3.2 852-858 Glenferrie Road Hawthorn

852-858 Glenferrie Road, Hawthorn

| Application no.: | PP19/00504 |

STATUTORY PLANNING OFFICERS REPORT Urban Planning Special Committee

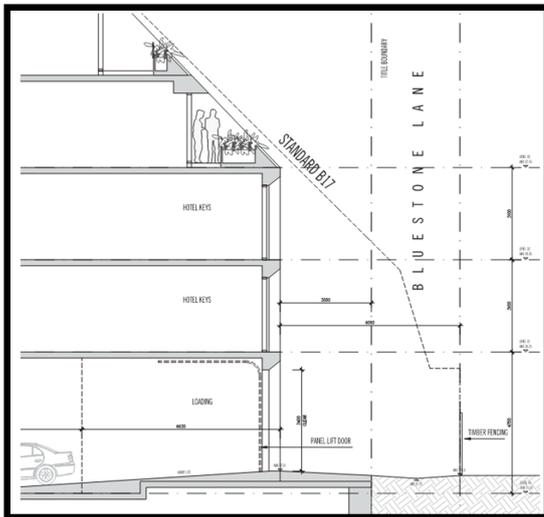
All vehicular access to the subject site is proposed to be provided via the rear laneway to three levels of basement car parking, in accordance with the above policy requirements.

The laneway is proposed to be widened by 3.05 metres into the subject site which will improve the overall functionality of the laneway. Council's Traffic and Transport Department have advised the laneway can accommodate the anticipated traffic volume generated by the proposal. Further details on this matter are contained in the referral section of this report.

Above: Comparison of street wall heights.

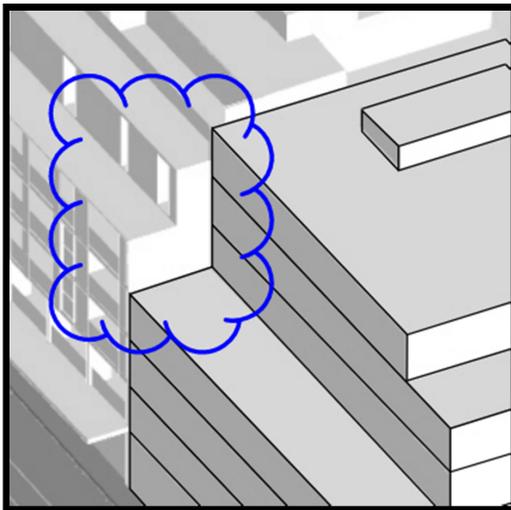
The proposed street wall height exceeds the discretionary street wall height by 3.5 metres. This proposed street wall height of 15.5 metres will provide an appropriate transition in scale between the street wall heights of the two adjoining buildings at No. 862 Glenferrie Road and No. 850 Glenferrie Road, Hawthorn. This is demonstrated as follows:

The proposed street wall height is essentially one storey lower than the street wall height of the adjoining apartment building at No. 862 Glenferrie Road and one storey higher than the DDO15 discretionary street wall height. The proposed street wall height will assist in obscuring views of the southern blank wall of the building at No. 862 Glenferrie Road as viewed from Glenferrie Road. It is considered the proposed street wall height will not act as a negative precedent for future development in this Precinct, but is rather a context responsive transition to the discretionary street wall height for future development to the south.
